8.4.2 Power and Energy Calculations based on Flow Duration Curve (FDC) method with Three (03) No. of Generating Units

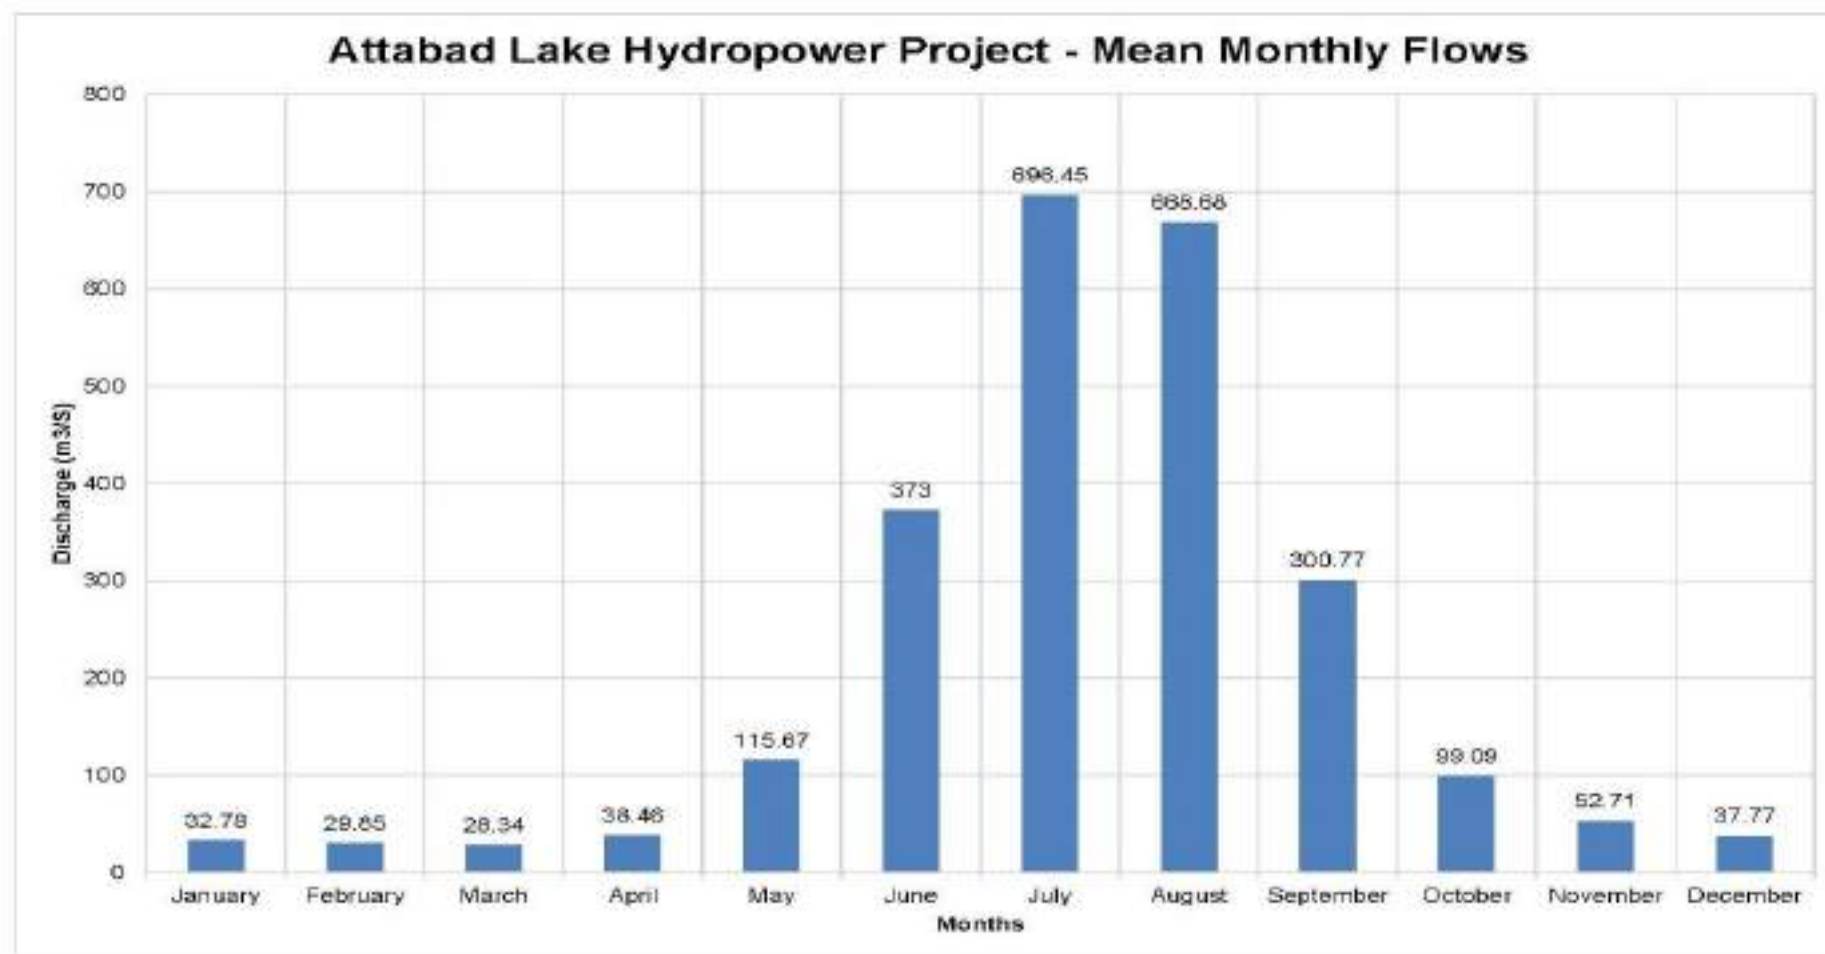
$$\text{Plant Factor} = \frac{372.8 \times 10^6}{54.04 \times 8760000} = \frac{\text{Actual Energy}}{\text{Theoretical Energy}}$$

Plant Factor = **78.74%**

Figure 9.6: Water Level Variation in Surge Tank

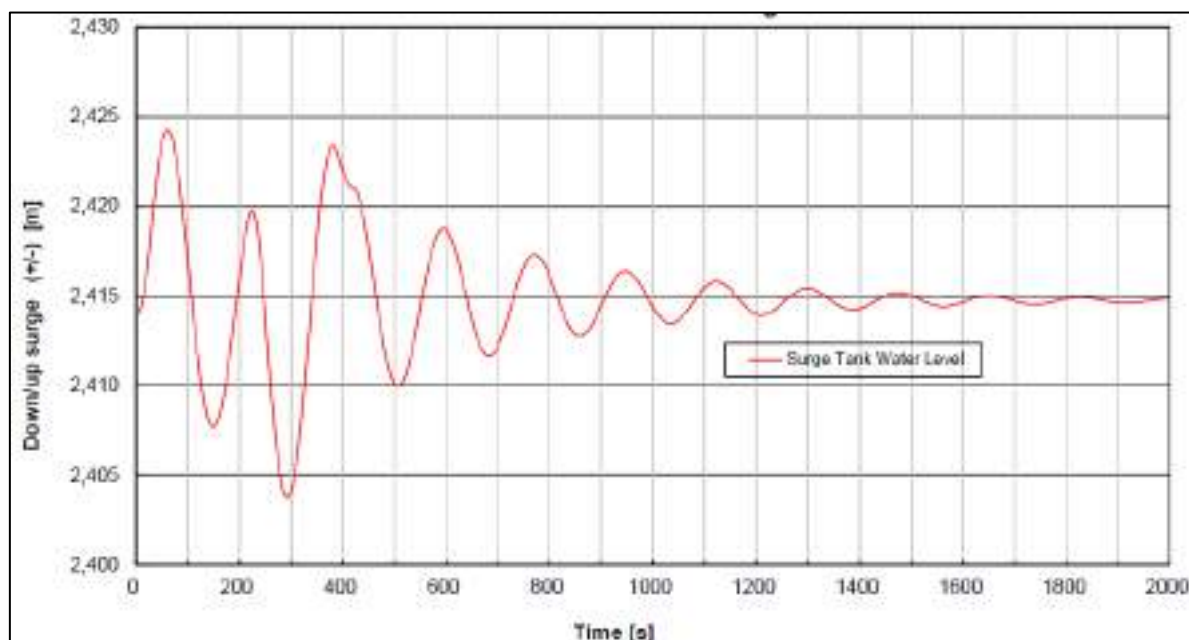
During the examination of upsurge and downsurge conditions, an initial elevation should be used for $T=0$ sec, taking into account the losses in the conveyance system and the maximum and minimum water elevations of the reservoir. For downsurge, minimum water level and maximum system discharge (for 3 turbines) and on-off scenarios should be used while the system is stopped. For Upsurge, calculations should be made in case of sudden load rejection of 3 turbines operating at maximum flow rate at the maximum elevation of the reservoir. In this case, the losses should be taken into account when determining the initial level of the surge tank. In other words, it is not a correct approach to take the direct reservoir water level inside the surge tank. Upsurge and downsurge graphs should be determined by the EM equipment manufacturer for various operating and accident scenarios and given as separate graphs.
